AMENDMENT OF SOLICITATION/MODIFICATION OF CONTRACT			1. Contract Number DCKA-2007-R-0003	Page of Pages 1 19
2. Amendment/Modification Number 2	3. Effective Date 6/27/2007	4. Requisition/Purchase Request No.	5. Solicitation Caption Metropolitan Branch Trail Contract

AMENDMENT NO. 2 **ISSUED** **June 27, 2007 Page(s)** **DCKA-**
2007-R-0003

METROPOLITAN BRANCH TRAIL

Amendment #2 is being issued to answer questions raised on the Metropolitan Branch Trail at the Pre-Proposal Conference held on June 13, 2007.

Lighting Needs for Area of Trail south of New York Avenue

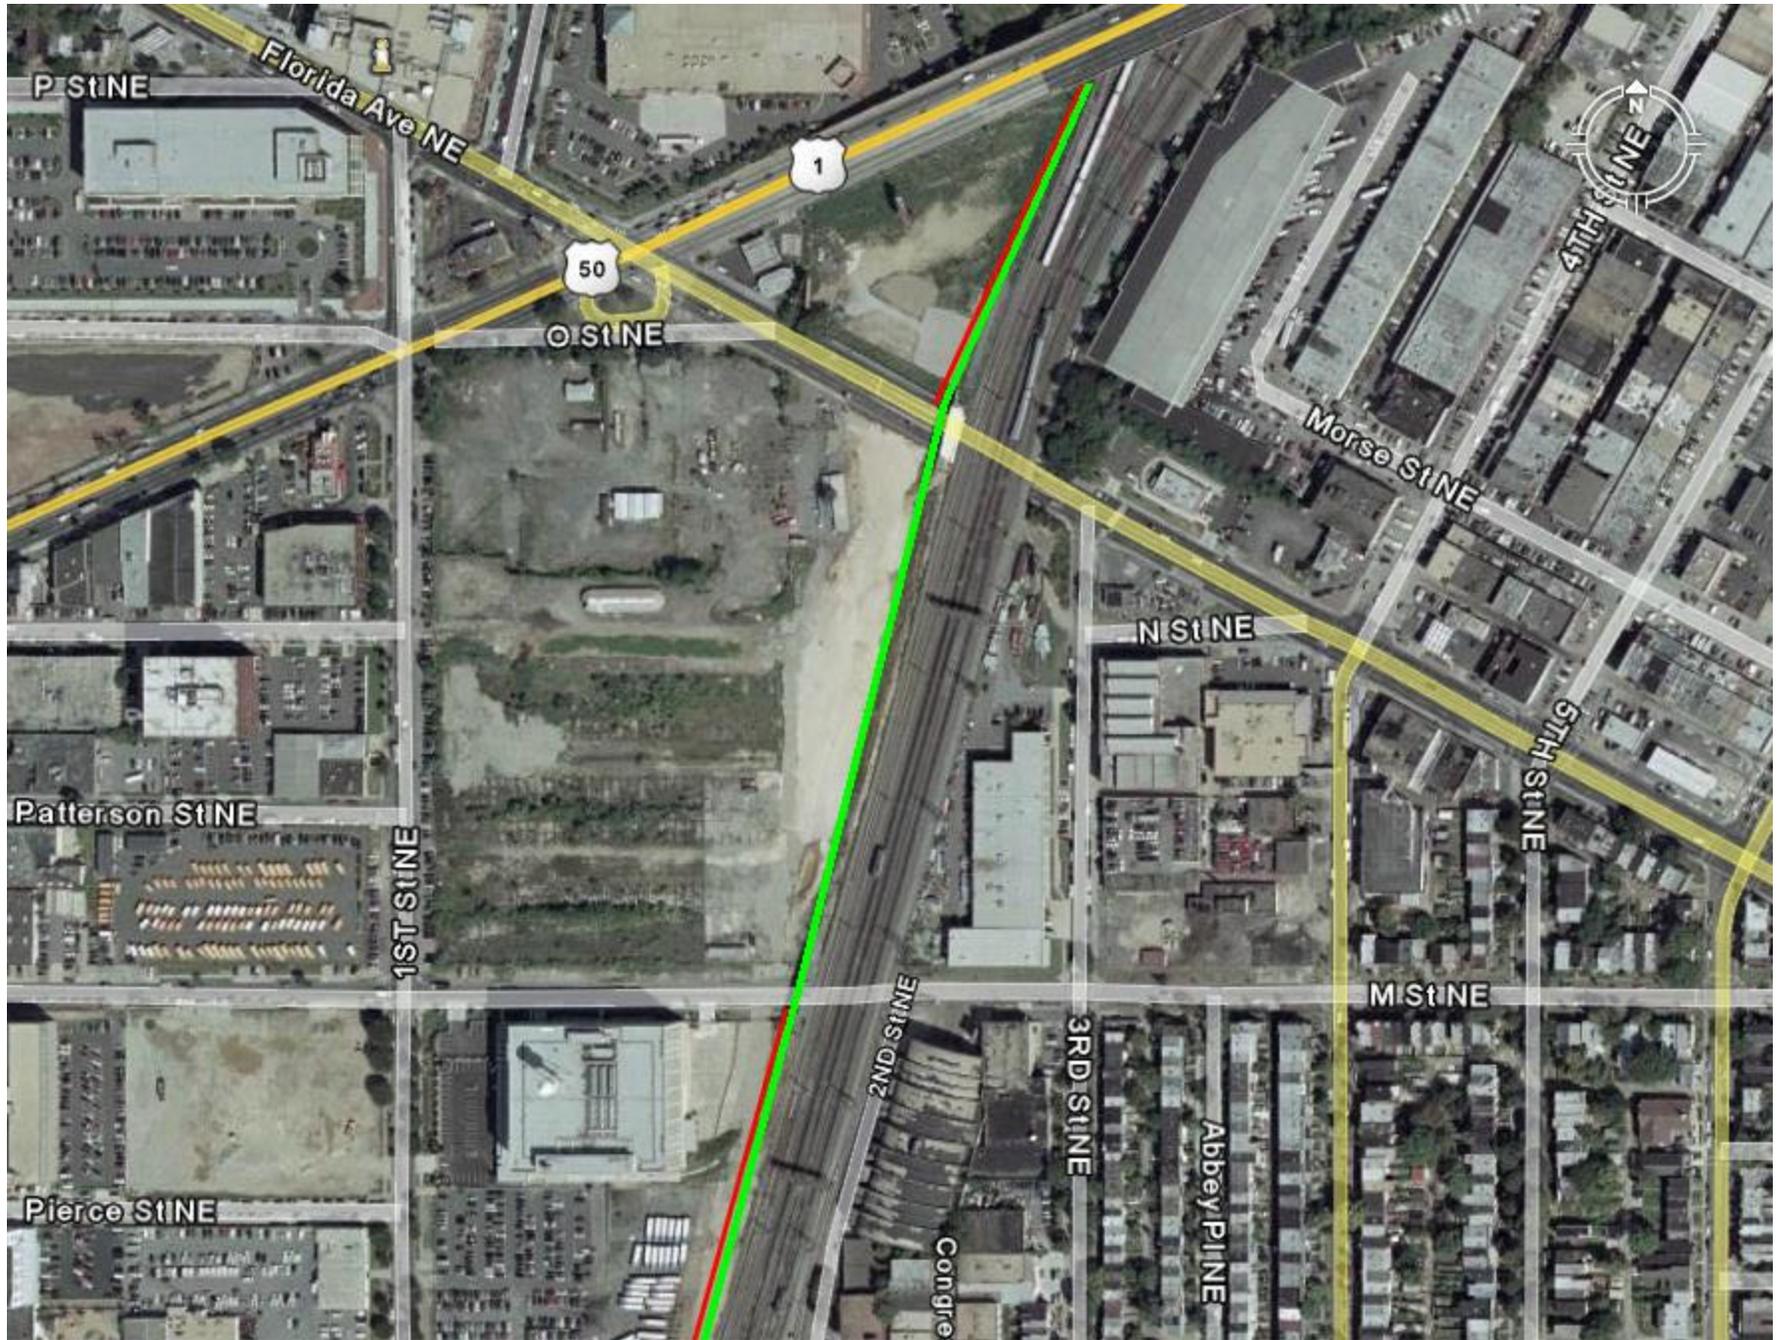
19. MAP of Lighting Area South of NY needed.

RESPONSE: See attached map.

Existing Trail - Green line

Lighting needed – Red line
